# The City of Grove City, Ohio

Planning Commission Staff Report  
Council Chambers  
September 4, 2018 1:30pm

### 3. APPLICATION: Byers Pre-Owned Center | Development Plan

Proposal: A development plan for a 6,724 square foot pre-owned automotive dealership

### Buildings

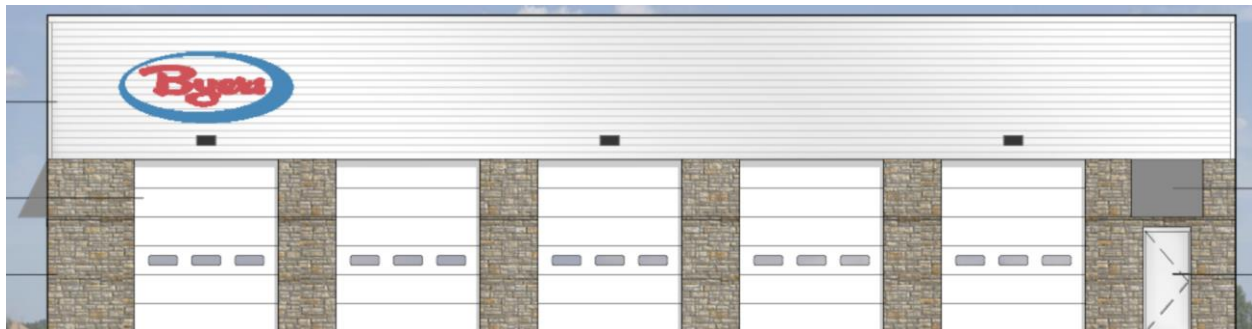
The proposed building will be 6,724 square feet in size (82' x 82') and will be one-story in height with a proposed height of 22 feet, meeting the maximum height requirement of 35 feet in the Gateway Business Park Zoning Text. The building will be finished primarily in stone veneer (Provia Limestone "Buff"), with the upper section of the building to be finished in metal paneling (Kingspan Design R Wall "Bright Silver Metallic"). A red entrance canopy is proposed over the building's primary entrance to provide additional architectural interest to the structure.

A dumpster is not proposed on this site. The applicant has indicated that the dumpster will be shared with the current Byers Auto dealership located adjacent and to the south. Staff is supportive of the use of a shared dumpster as long as a shared agreement is made between the two properties.
